EXHIBIT "A"
SB-20120008
ST. LUCIE NORTH DRAINAGE BASIN IMPROVEMENTS
GENERAL REQUIREMENTS

**CONSTRUCTION PLANS
 OF
 ST. LUCIE NORTH DRAINAGE
 BASIN IMPROVEMENTS
 FOR
 CITY OF PORT ST. LUCIE, FLORIDA
 LYING IN
 SEC. 6, 11-13, 17&18, TWP. 36S., RNG. 39&40 E.
 ST. LUCIE COUNTY, FLORIDA**

Job No. 779.1.1
 SHEET 5 OF 26

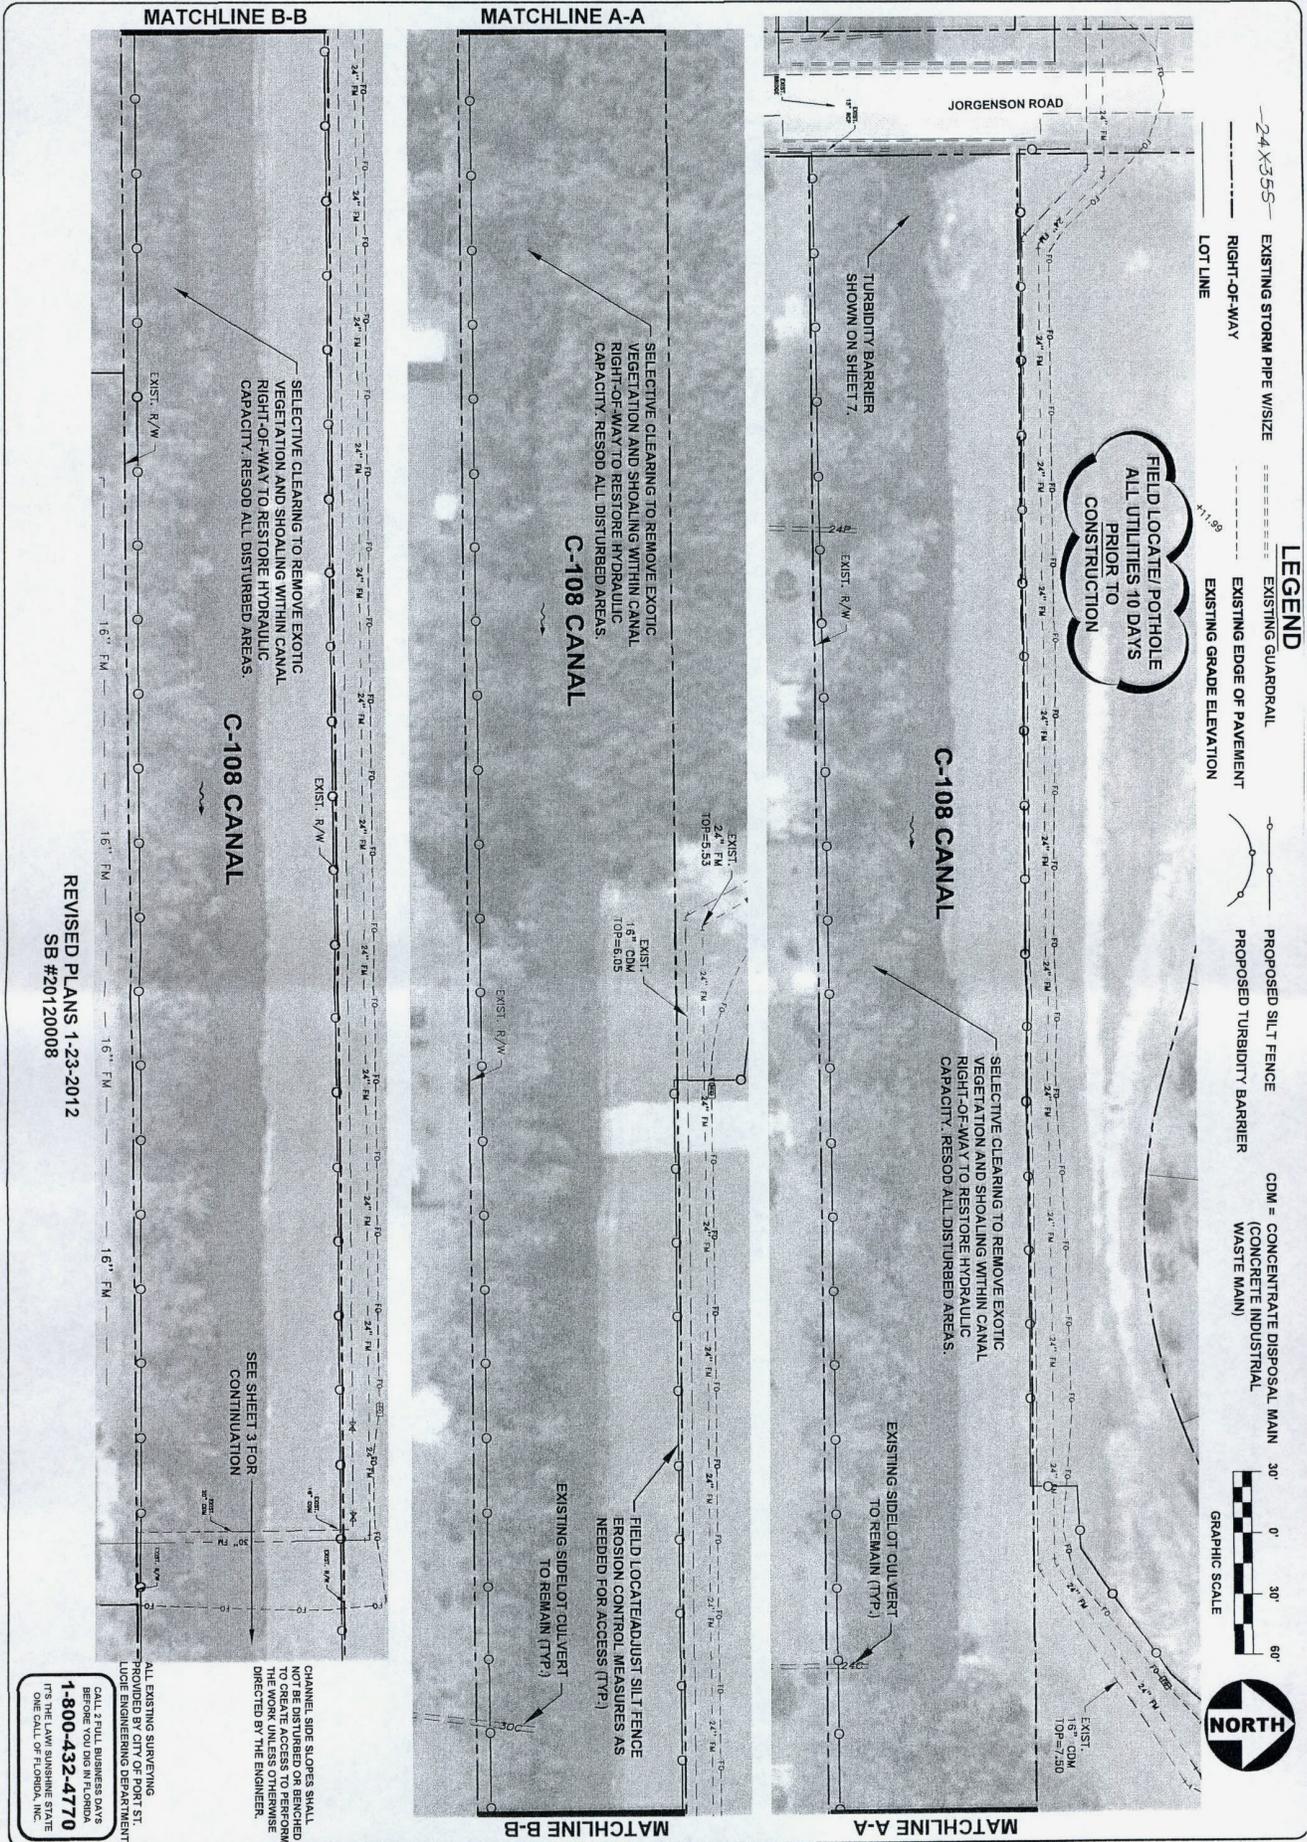
Q 9: On Sheet 5 there is a section of the C-108 Canal that crosses the southern section of the wetland on Sheet 6. The plans state to restore hydraulic capacity to an area that appears to be part of the wetland and never graded to a particular canal cross-section. Additionally there is no Excavation pay item in this Schedule. Should this area be excavated and graded, cleared of exotics and left as is or hand cleared as if part of the wetland and left as is? Please clarify.

Q8. On sheet 5 of the plans. It indicates to clear selective exotic vegetation on the south side of the C-108 Canal. How would you propose to do such removal without accessing private property?

JOB No.: 779.1.1
SHEET 6 OF 26

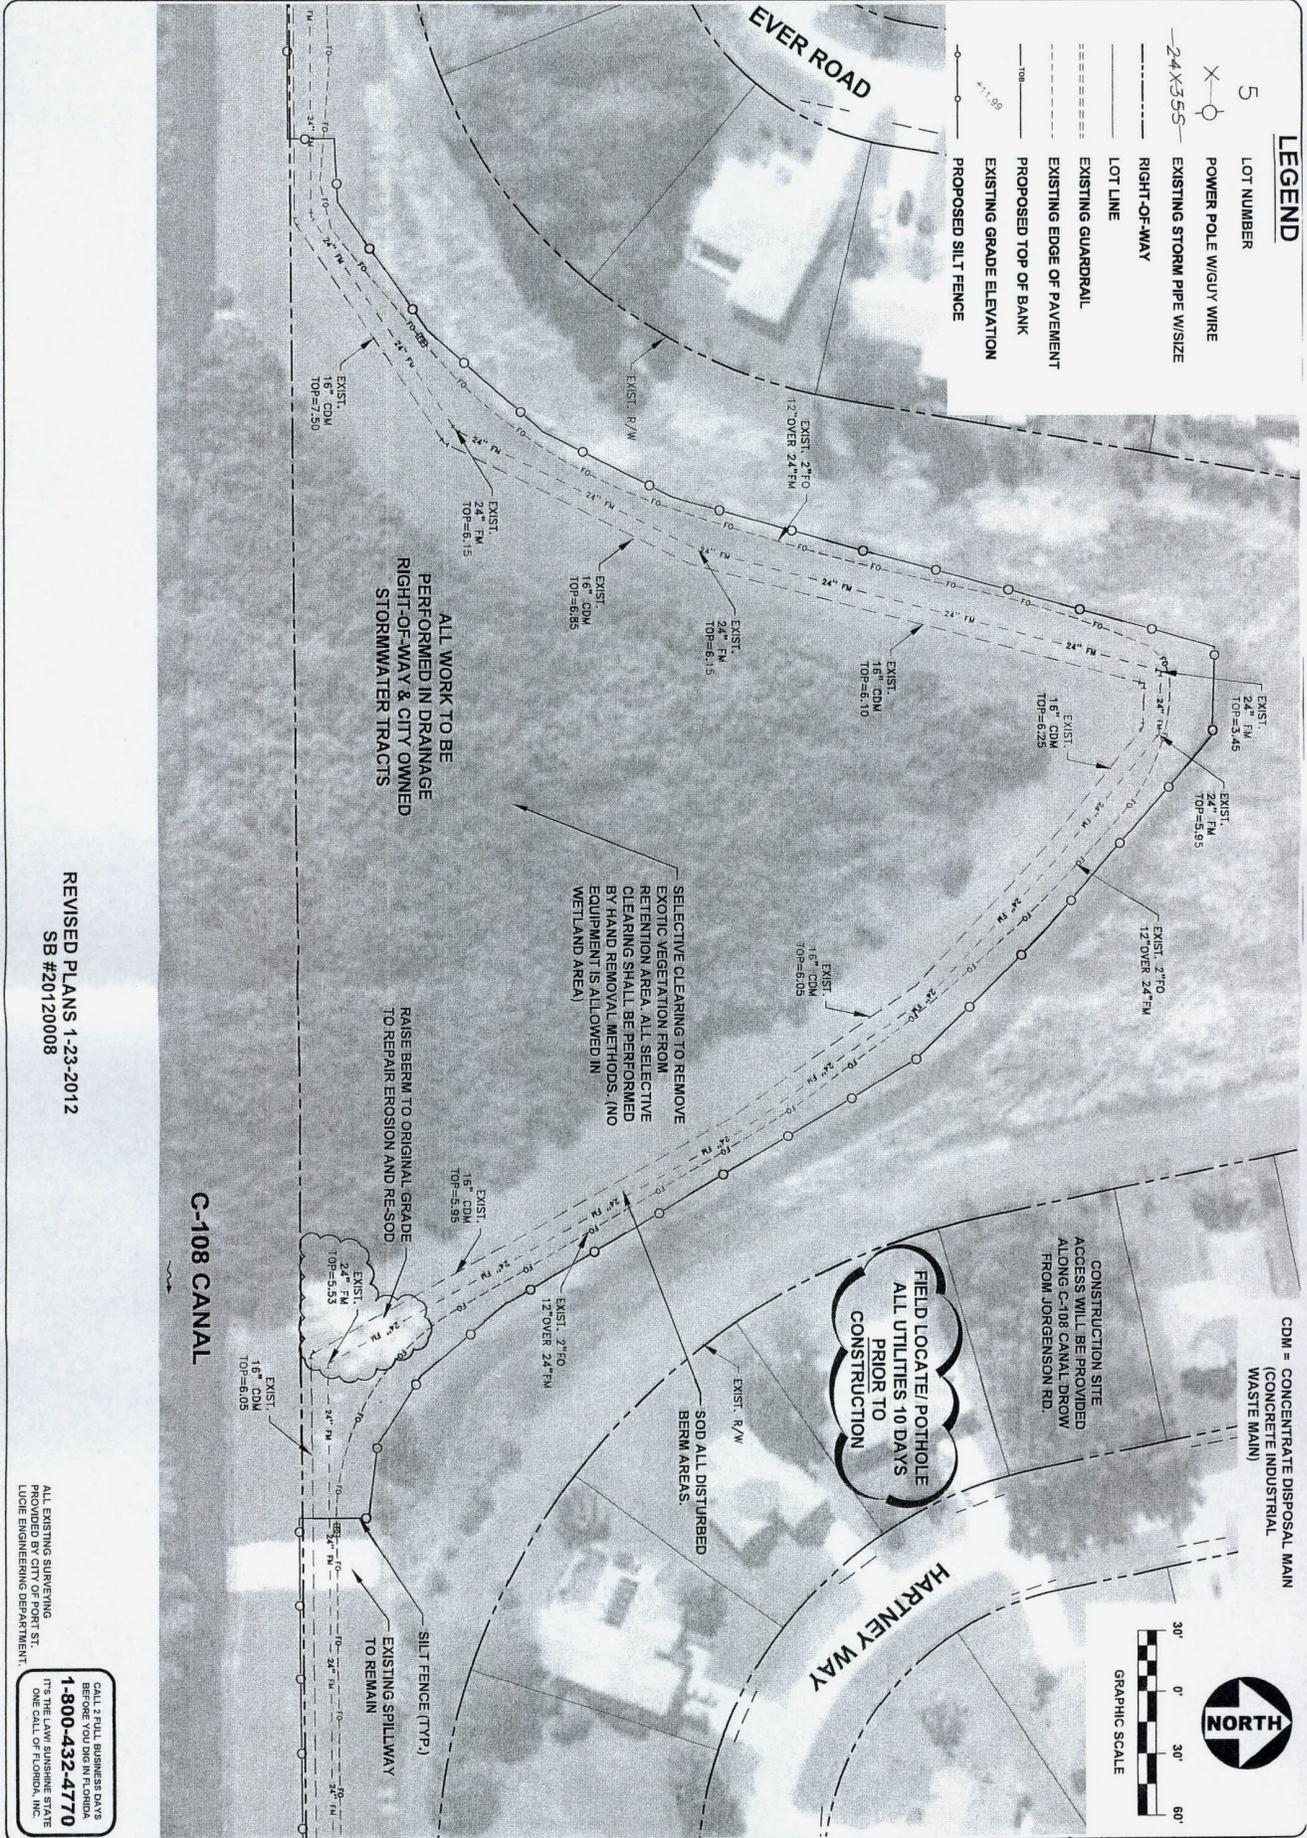
Q 10: During a site visit it was observed that the existing spillway shown on Sheet 6 has significant undermining and settlement. Is this to be repaired?

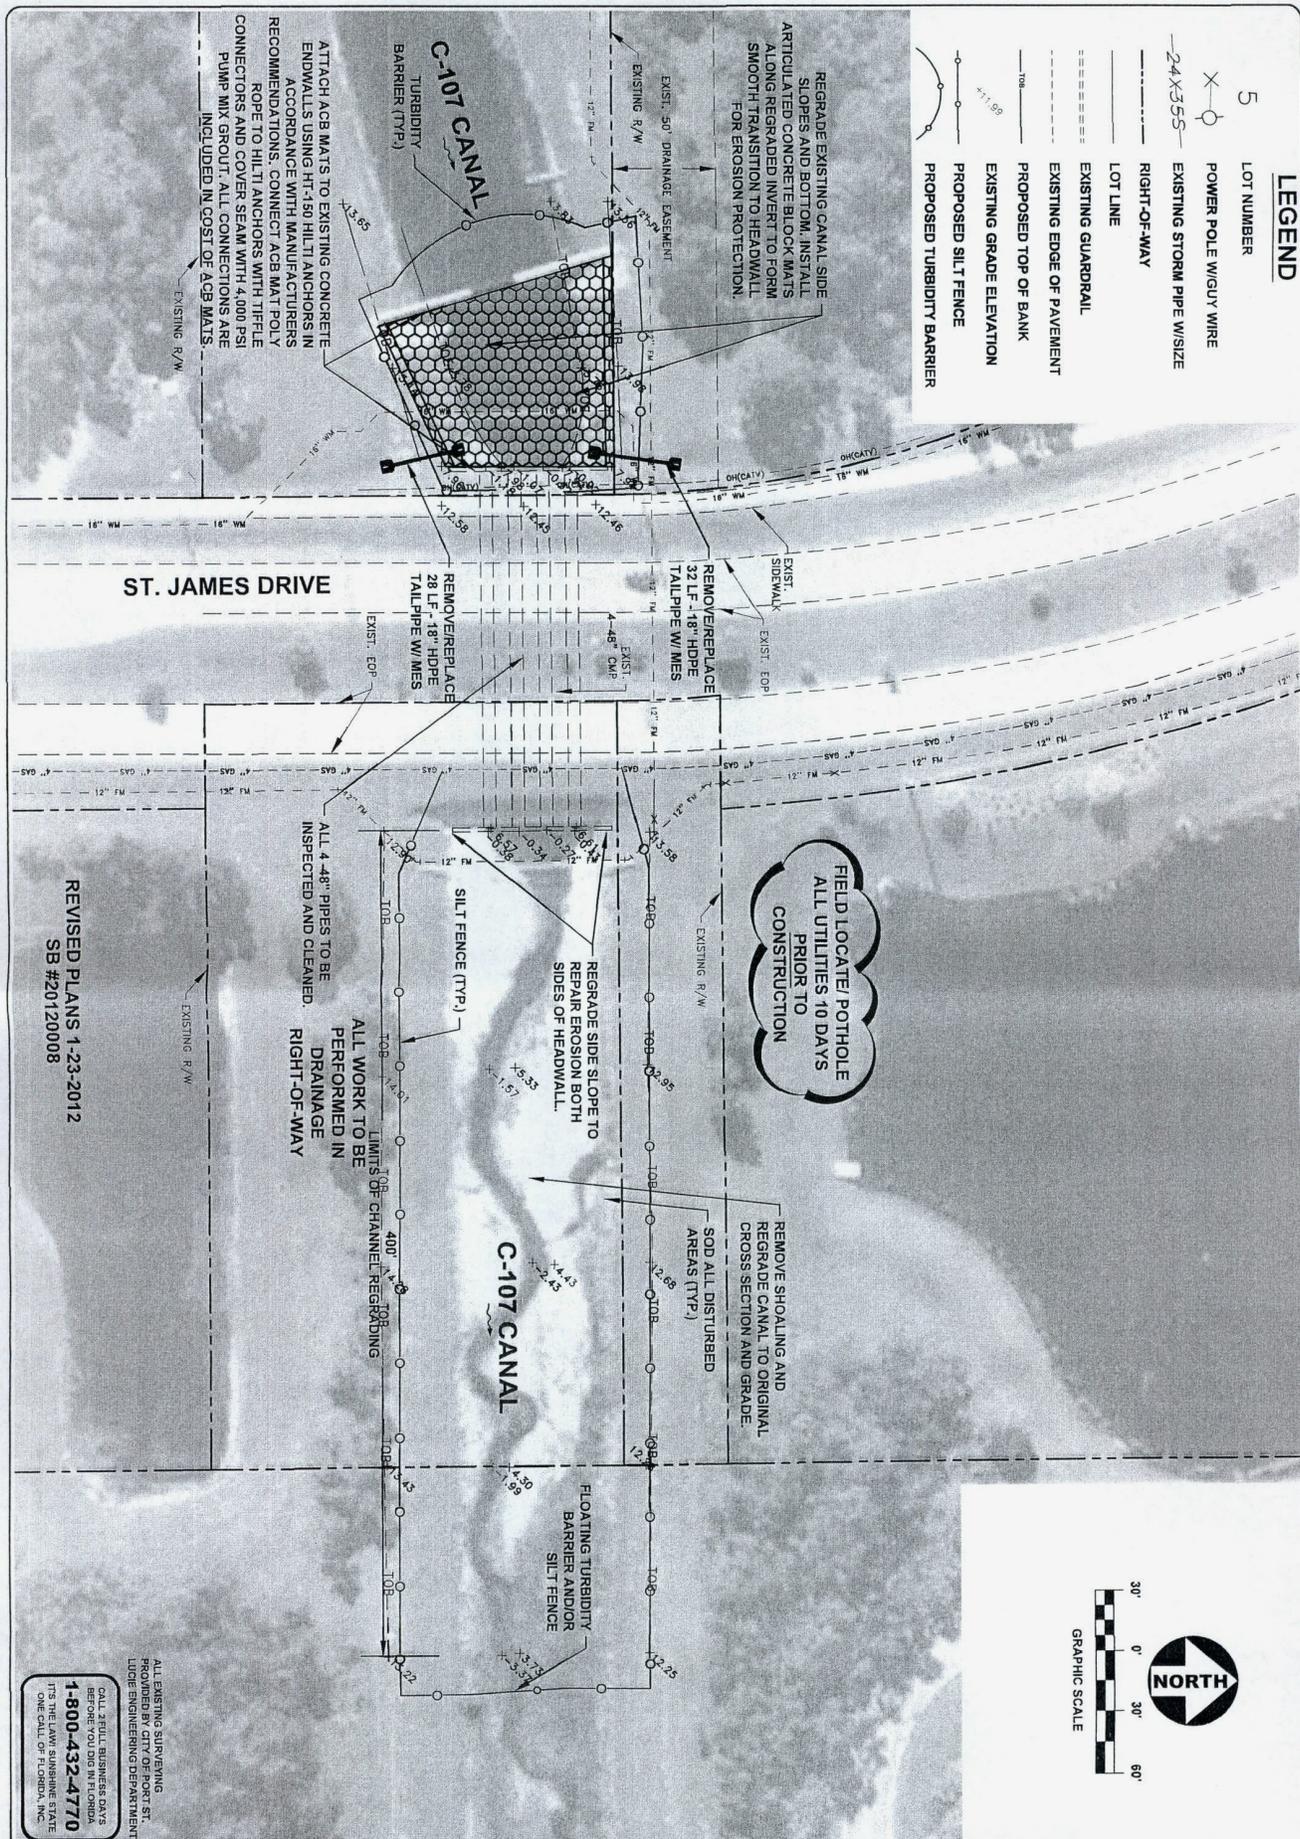
Q 4: There is a detail on Sheet 21 for a baffle, however it is unclear if and where baffles are required. Can you please clarify if baffles are required, and if so, on which structures?

A 4: The baffle detail is for Control Structure CS-1 (only) that is part of the C-107 Canal Dry Detention Pond improvement as shown on sheet 11 of the plans.

Job No.: 779.1.1
SHEET 13 OF 26

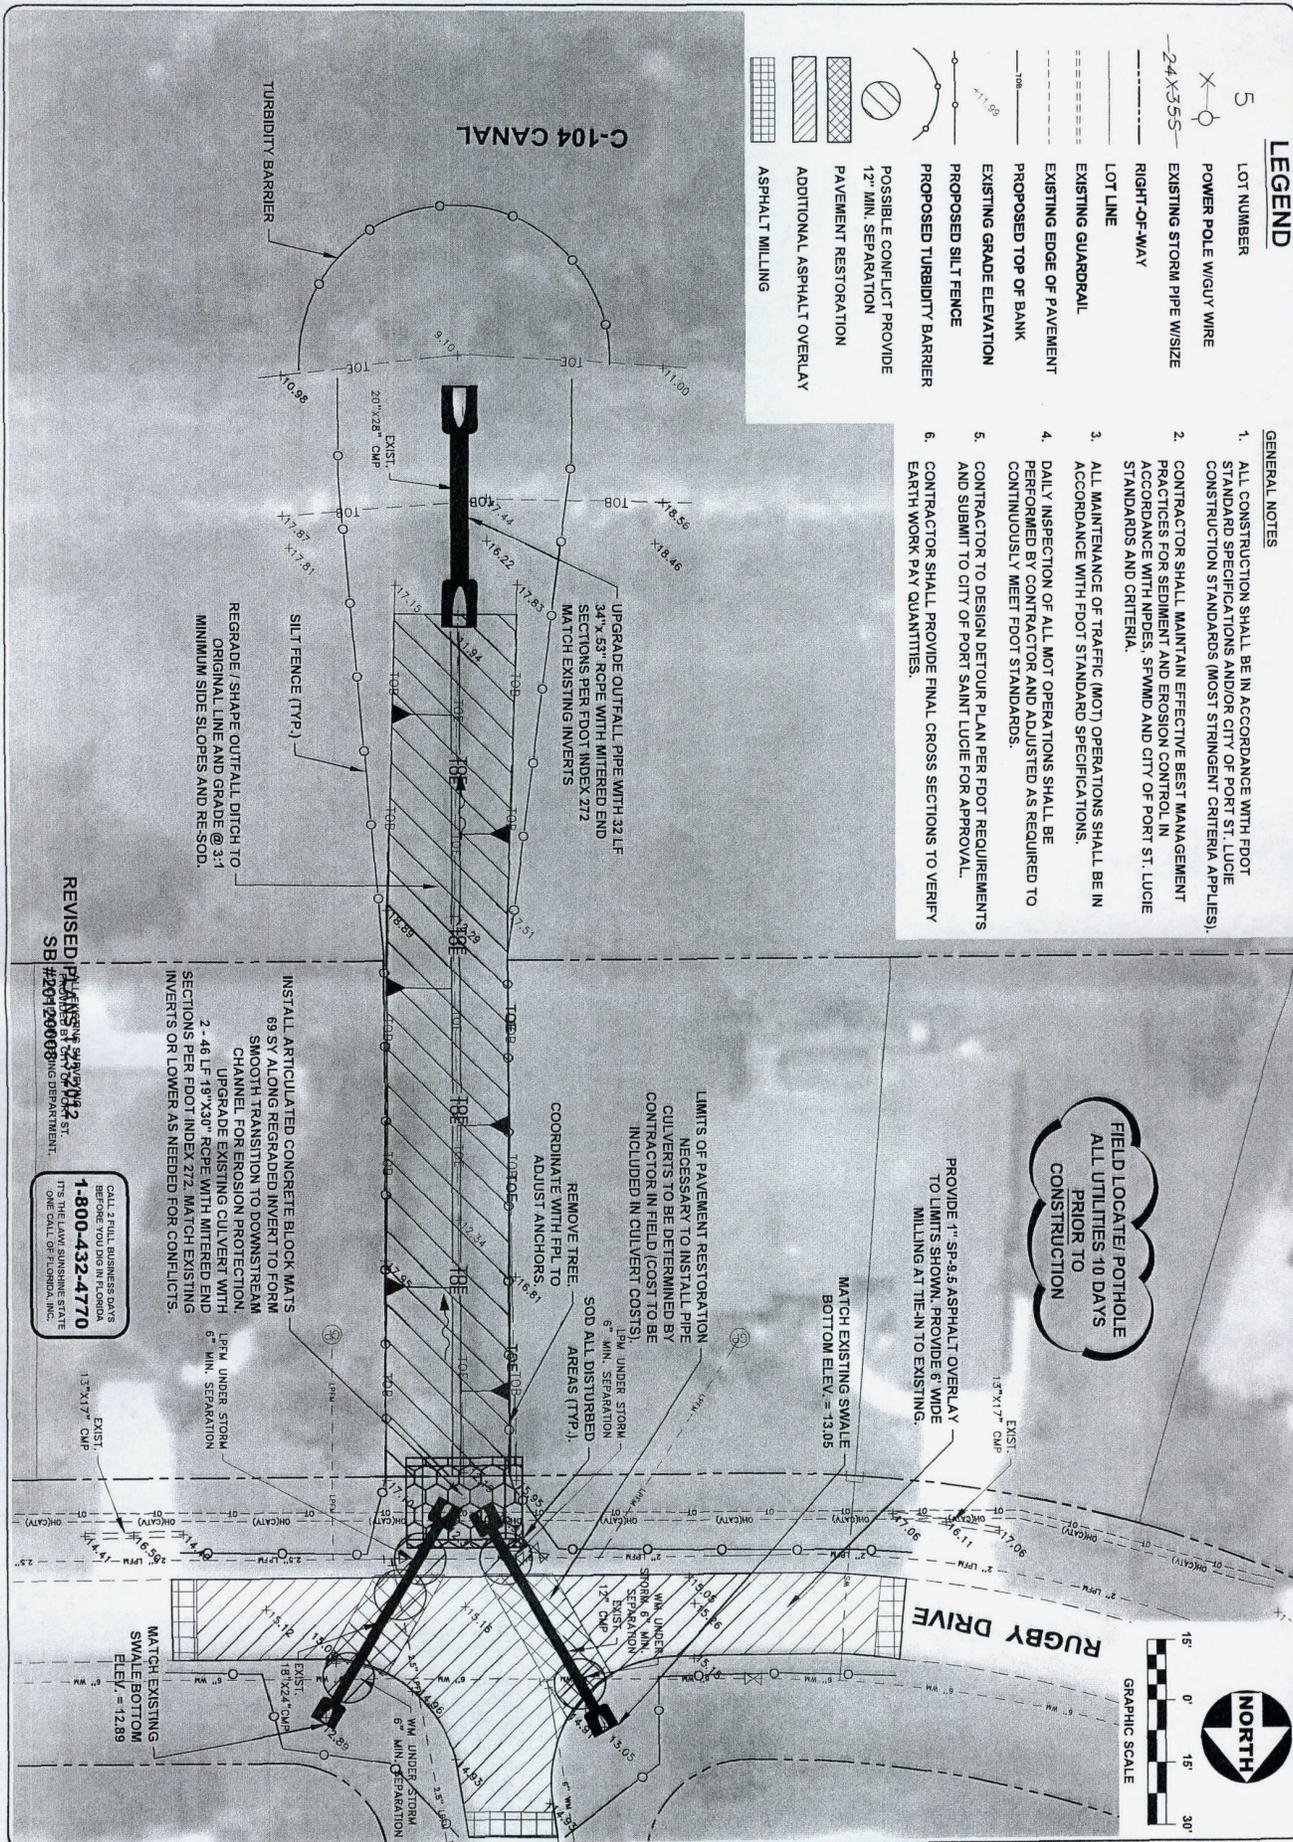
Q4. On sheet 13 of the plans. Could you please provide dimensions and/or limits of the fabri-form repair?

Q5. On sheet 13 of the plans. "Remove and replace 20LF of HDPE..." We measure the distance from the headwall to the end of pipe and it was approximately 45 feet. Is your intention to reshape the swale and install only 20LF of pipe?
